SEWAGE DISPOSAL SYSTEM

DEPARTMENT OF HEALTH AND MENTAL HYGIENE

A REPAIR

SUBDIVISION _____ LOT 250 ROAD 11178 Douglas Avenue

P 46507

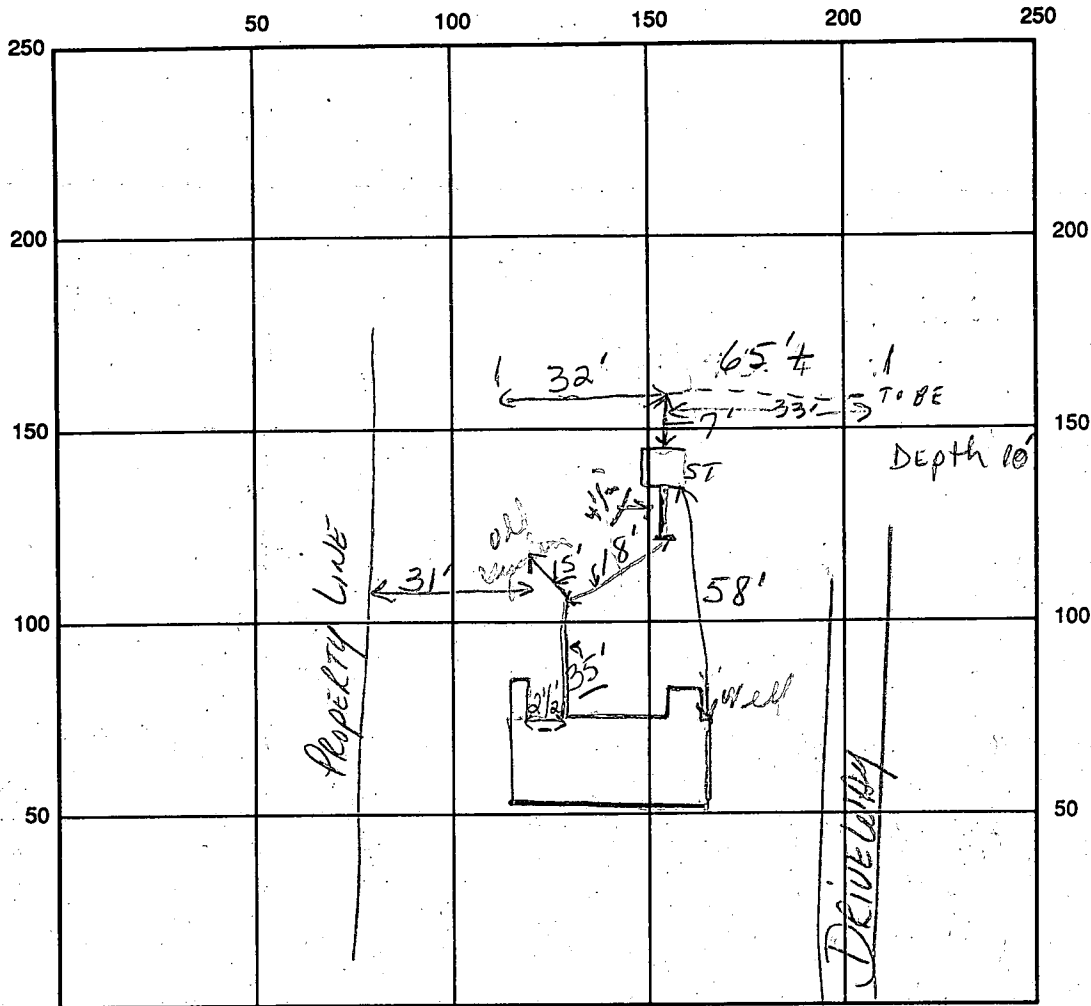
REMARKS: A.M. 10-4-90 PARTIAL COVER FROM HOUSE TO SEPTIC TANK
TO PROVIDE DRAWING FROM SEPTIC TO TRENCHES J.B.G.
& DEPTH 10' LENGTH & INLET TO TRENCHES. C.B.
P.M. SEPTIC TANK ONLY - NO WORK ON TRENCH PARTIAL C.B. & J.B.G.
10/4 P.M. HOLD FOR A CALL. 10-5-90 TRENCH TO BE 65' ± 10' DEEP 2' WIDE
TO COVER AS FINISH - MATERIAL ON SITE J.B.G. & C.B.
